AGENDA
PLANNING COMMISSION
116 WEST NEEDLES
BIXBY, OKLAHOMA
December 17, 2012 **6:00 PM**

**MINUTES
PLANNING COMMISSION
116 WEST NEEDLES
BIXBY, OKLAHOMA**

To: Bixby Planning Commission
From: Erik Enyart, AICP, City Planner
Date: Friday, November 09, 2012
RE: Report and Recommendations (Revised 11/19/2012 to reflect the revised plats and information received 11/19/2012) for:
Preliminary Plat (Resubmitted) & Final Plat of “Seven Lakes II”

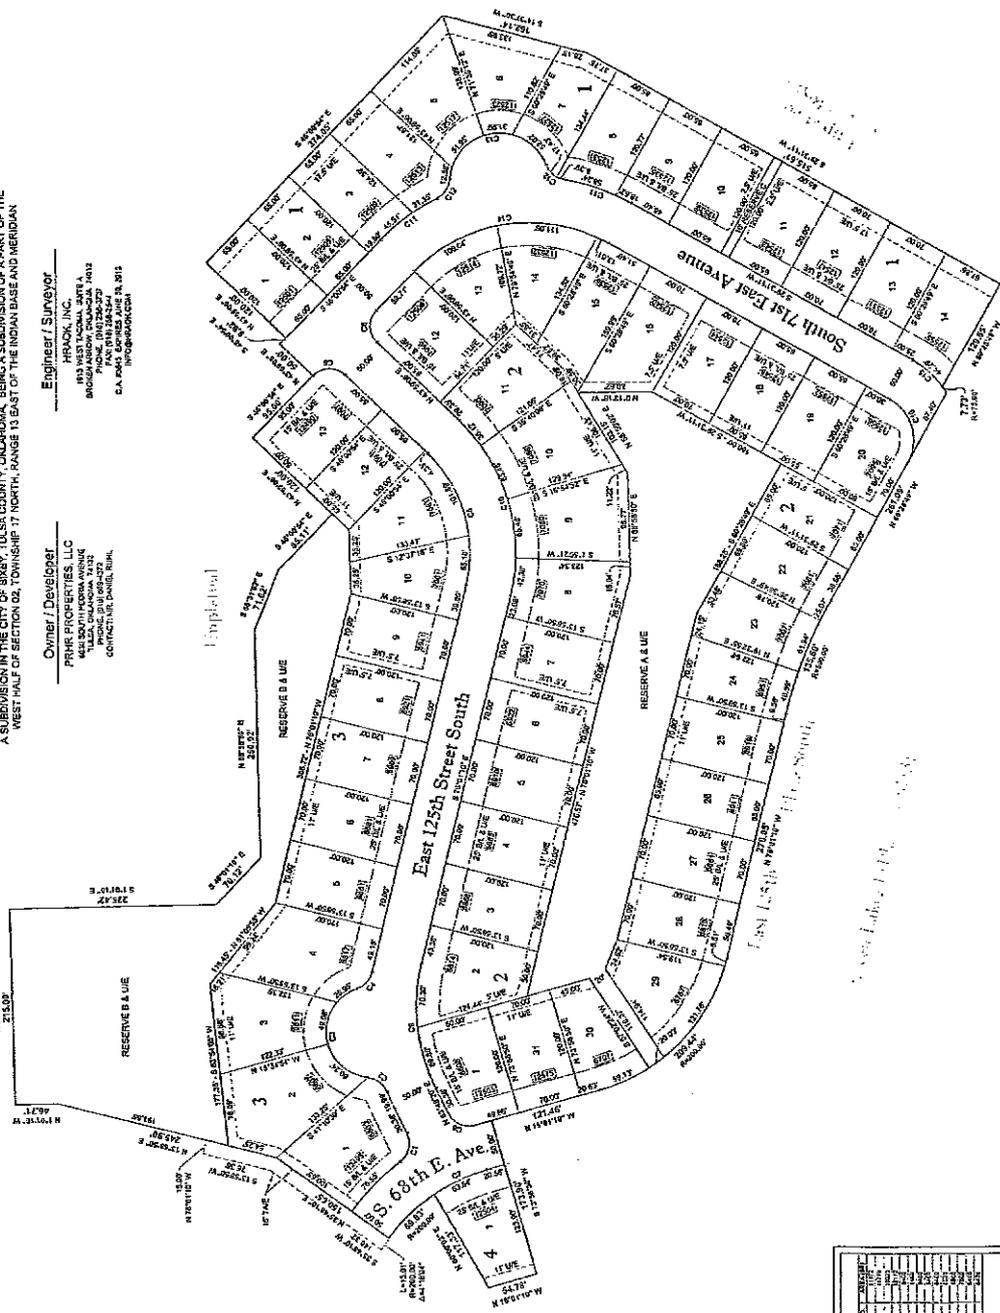
1. Subject to a Modification/Waiver from Subdivision Regulations Section 12-3-4.F, as Lot 15, Block 2, and Lot 7, Block 1 (and potentially others) appear to exceed the 2:1 maximum depth to width ratio as per SRs Section 12-3-4.F. The Modification/Waiver may be justified by citing its necessity as a product of an attractive subdivision design defined by the crisscrossing, curvilinear street network with no true cul-de-sacs, interspersed with Reserves for water amenities.

3. Subject to compliance with all Fire Marshal, City Attorney, and City Engineer recommendations and requirements.
4. Unlike the other water amenity reserves in Seven Lakes I, Reserve B has no 'handle' to provide access. Access is necessary for routine maintenance and emergency access. Handle access is to be a minimum of 20' in width, per previous City Engineer recommendations. However:

7. As per an earlier version of this plat, the street connecting E. 125th St. S. to S. 71st E. Ave. was previously designated E. 124th Pl. S. Based on the provided addresses, S. 71st E. Ave. is implied. Depending on the future street network layout of the future phase of Seven Lakes immediately to the north, it may more appropriately be designated E. 124th Pl. S. or S. 71st E. Ave. For emergency 911 response, mail service, and general addressing purposes, please provide this street name and clearly differentiate street segments at the intersections. If to be E. 124th Pl. S., re-address the affected lots.

A101

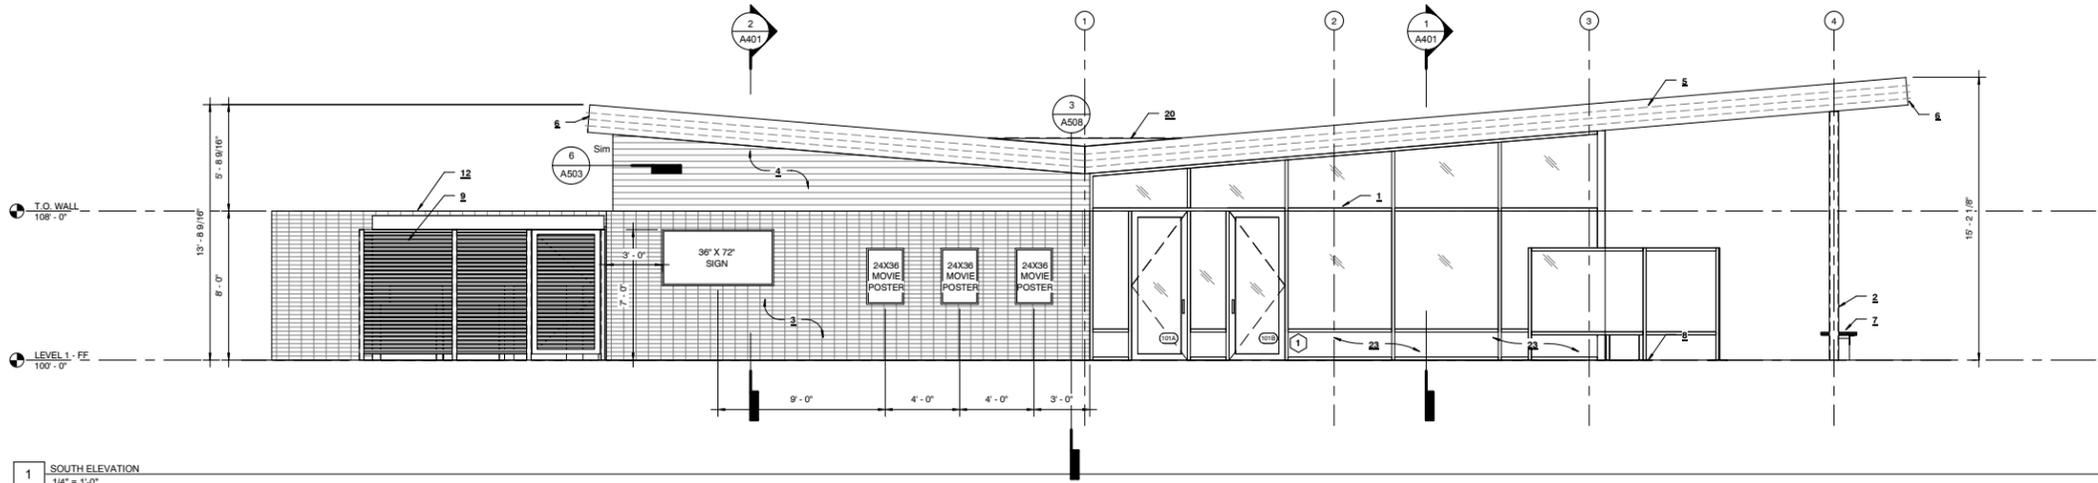
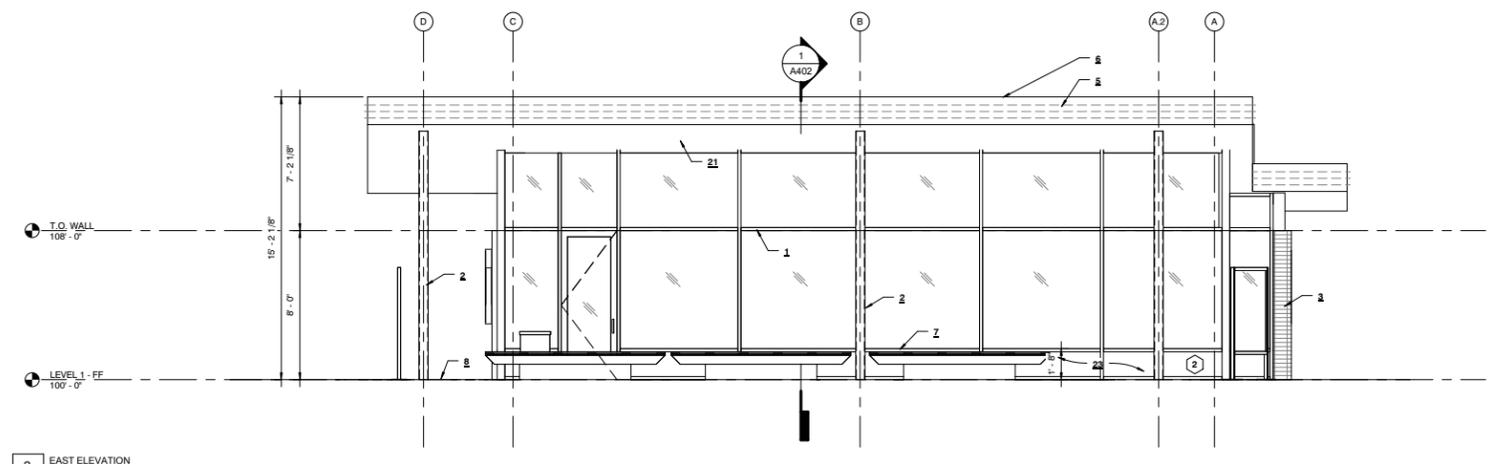
The "Site Plan" drawing A101 indicates the location of one (1) "monument" (actually a pylon) ground sign at the southwest corner of the lot, and two (2) menuboard signs north of the building at the drive-through entrance. The "Site Plan" drawing by Lewis Engineering, P.L.L.C. indicates the location of this ground sign, but does not identify it, and does not indicate or identify either menuboard sign.

23. Please resolve the Lot Percentage Landscape Standard (Section 11-7I-5.F; PUDs only) matter as described in the Landscape Plan analysis above.
 24. Please correct “monument” qualifier of the ground sign on the “Site Plan” drawing A101 to “pylon” or “ground” sign.

26. Please represent all proposed menuboard signs on the sign plans for approval as a part of this PUD Detailed Site Plan (PUD 63 Section E.2.b).
 27. A structure is indicated on the building “Elevations” drawings A301 and A302, which the provided Joplin, MO example photos indicate may be a menuboard sign, which would likely face east in this case. The structure is not labeled on drawings A301 or A302, and is not indicated on the plan-view site plan drawings. The Applicant should label as appropriate and provide signage information, if it is to be a sign, or remove from plans if not actually proposed for this site. If it is a menuboard sign, and if facing east, it would not appear visible from a public street, and so would appear to be permissible per Zoning Code Sections 11-7I-4.B.2.f.3 and 11-9-21.C.3.d.

- k. A 22'-wide linetype is indicated on "Site Plan" drawing A101 and on the "Site Plan" drawing by Lewis Engineering, P.L.L.C., but at 22' 2" in that case. The linetype does not appear to correspond to any geospatial features on the plat of *101 South Memorial Plaza*. The linytypes need to be labeled and, if pointing to the same geospatial feature, they need to be reconciled as to width.

A302

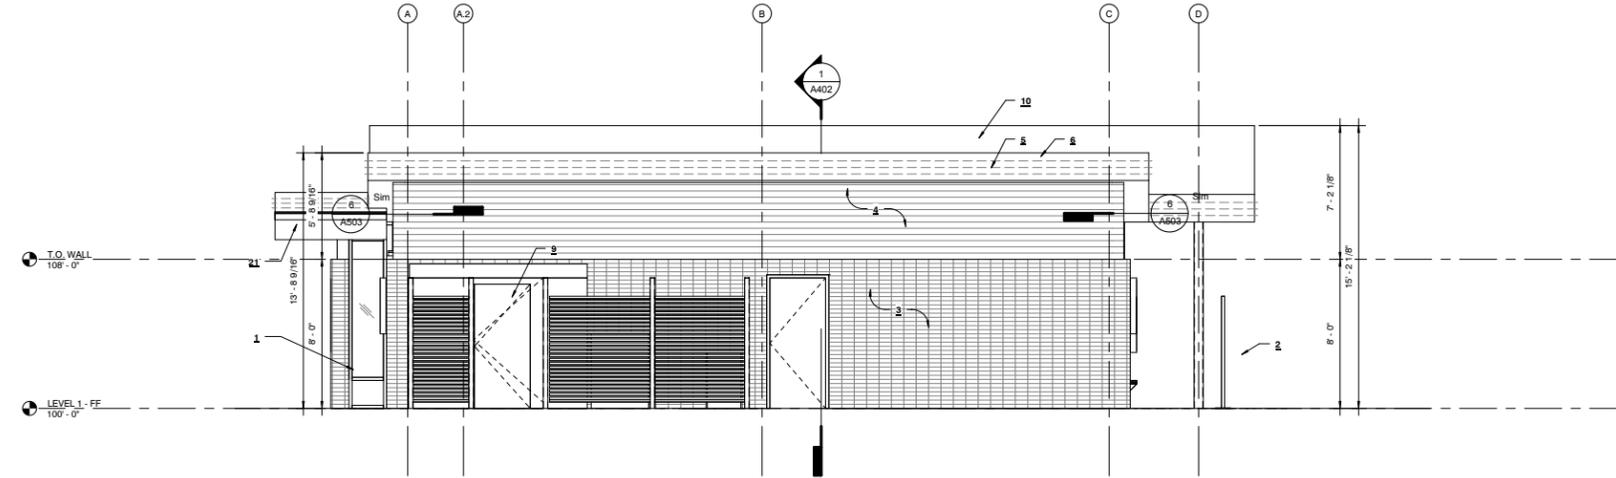
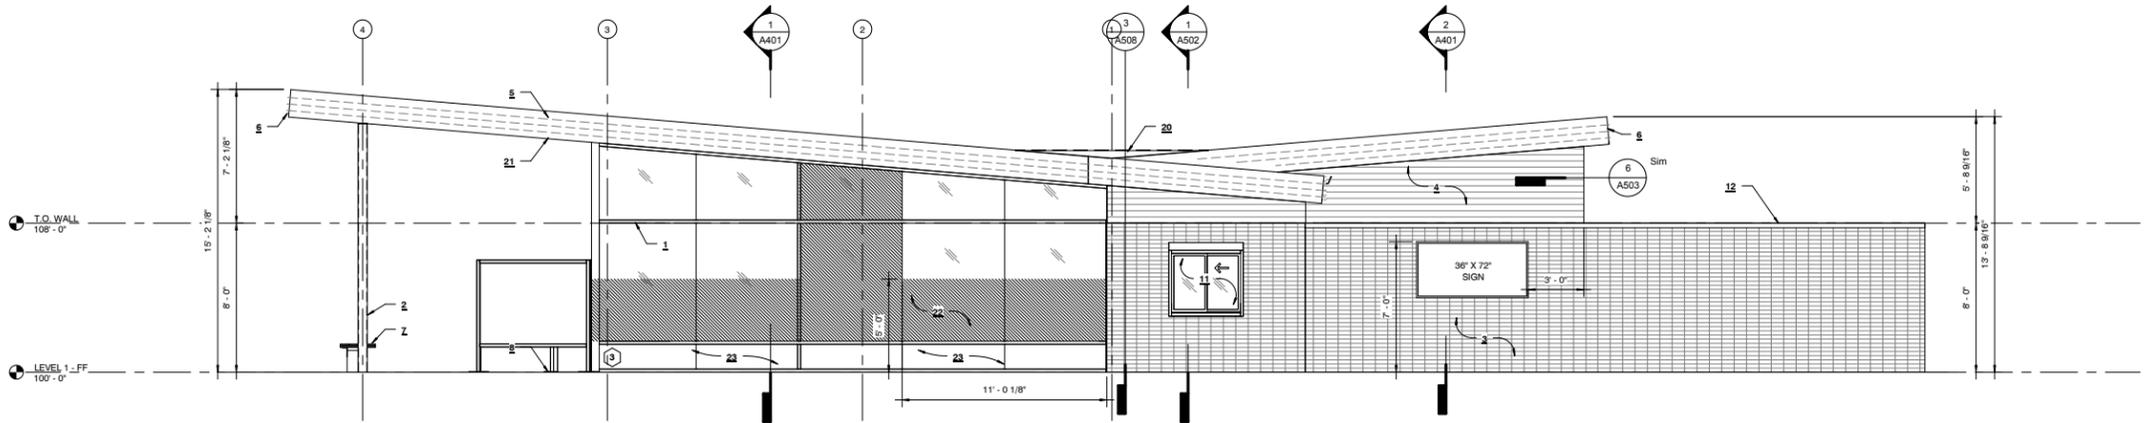
A structure is indicated on the building "Elevations" drawings A301 and A302, which the provided Joplin, MO example photos indicate may be a menuboard sign, which would likely face east in this case. The structure is not labeled on drawings A301 or A302, and is not indicated on the plan-view site plan drawings. The Applicant should label as appropriate and
